Approach for Responding to Draft Requests for Additional Information Related to NRC Review of Topical Report EPRI-AR-1(NP)

**Paul Demkowicz, Ph.D.
AGR Program Technical Director
Idaho National Laboratory**

December 9, 2019

Range of Normal and Off-Normal Accident Conditions

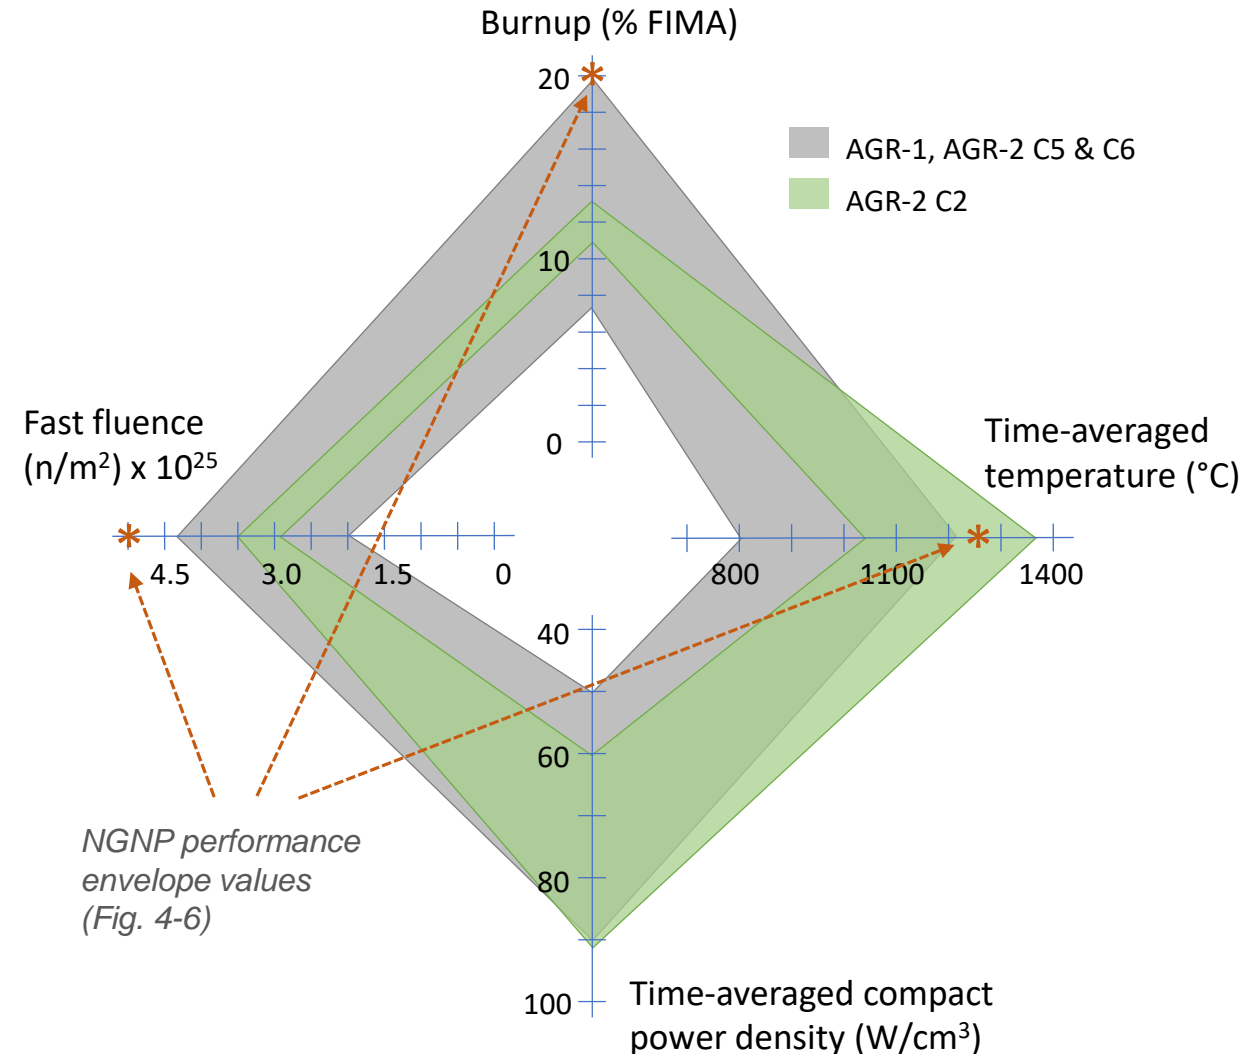
- Conclusion 1 of the TR states that “testing of UCO TRISO-coated fuel particles in AGR-1 and AGR-2 constitutes a performance demonstration of these particle designs over a range of normal operating and off-normal accident conditions.” Discussions under the conclusion reference a compact-averaged burnup of 7.3-19.6% fissions per initial metal atom (FIMA) and time averaged maximum temperatures of 1069-1360 C. Are there other relevant performance parameters that bound the data set, such as those referenced in Figure 4-6 (packing fraction, fluence, power density)? Based on the discussion in the report, it appears some of these parameters could influence particle performance, but these values are not provided as bounds for the “range of normal operating and off-normal accident conditions”. Provide context for what constitutes a “range of normal operating and off-normal accident conditions” (e.g. reference a table), or provide a justification for why burnup and time averaged temperature are sufficient.

- Yes, there are other irradiation conditions that are important for fuel performance in addition to burnup and temperature
- Key irradiation condition parameters will be summarized and presented in tabular and graphical form:
 - Temperature (time-averaged)
 - Power density (time- and volume-averaged)
 - Burnup
 - Fast neutron fluence
- Time-average values used where appropriate
- Detailed irradiation conditions are included in various tables and graphs in Section 6
- Accident conditions tested in the report are elevated temperatures (1600 – 1800°C) in dry helium for times as long as 400 hours
 - Not intended to bound or imply acceptable reactor accident conditions
 - Provide sufficient data for vendors to apply to their specific accident scenarios

Reference micrographs of
SiC with grains too large
(*AGR-1 Fuel Product
Specification, EDF-4380
Rev. 8, 2006*)

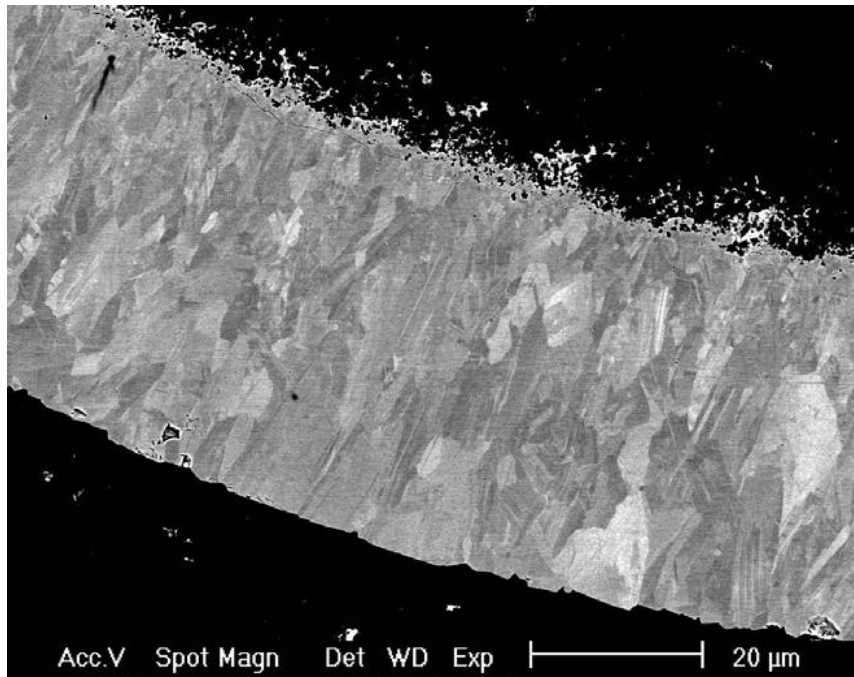
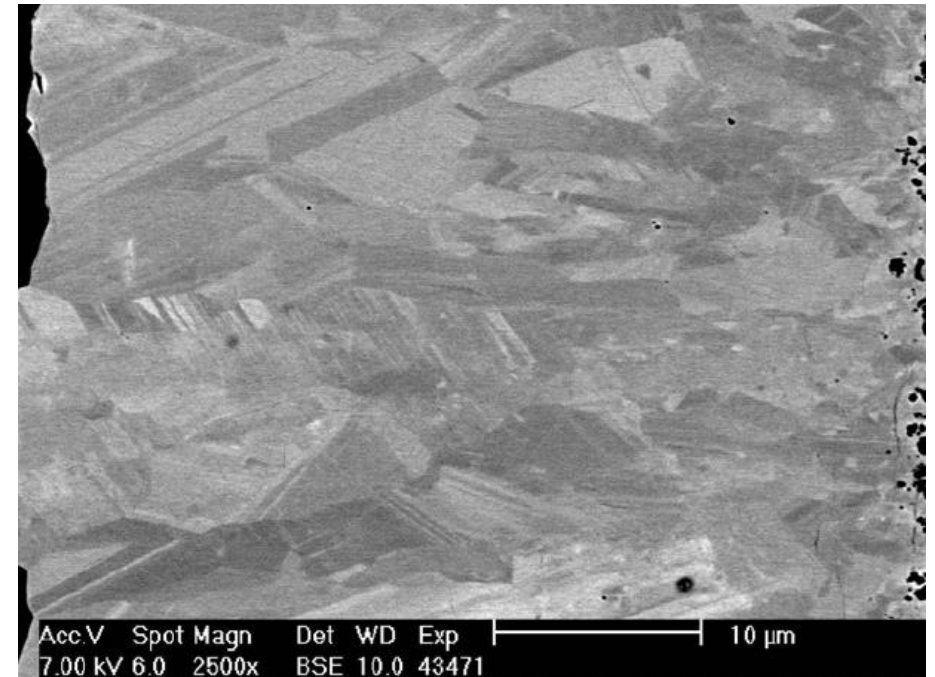
- Conclusion 2 of the TR states “UCO TRISO-coated fuel particles that satisfy the parameter envelope defined by these measured particle layer properties in Table 5-5 can be relied on to provide satisfactory performance.” While Table 5-5 provides a list of physical parameters for fuel specifications, it does not appear to directly cover all of the parameters that govern the specifications that constitute the parameter envelope applicable to the tested AGR fuel. Some elements in particular that the report highlights as important but that are not directly referred to in Table 5-5 include kernel-to-buffer ratio for the fuel particle (and potentially its associated size), columnar grain structure of the SiC, and carbon content of the UCO. It is not clear to the staff how these limits are applicable to the conclusions in the report. Provide a justification for how these parameters are implicitly captured in Table 5-5, supplement the report to include these parameters as limits for TR applicability, or provide justification for why these elements are not important.

- AGR Program did not have a quantitative specification for SiC microstructure (e.g., grain size, grain orientation, etc.)
- Used a “visual standard” to avoid excessively large grain sizes and unfavorable orientations (e.g., columnar grains)
- Visual standard will be referenced in RAI response
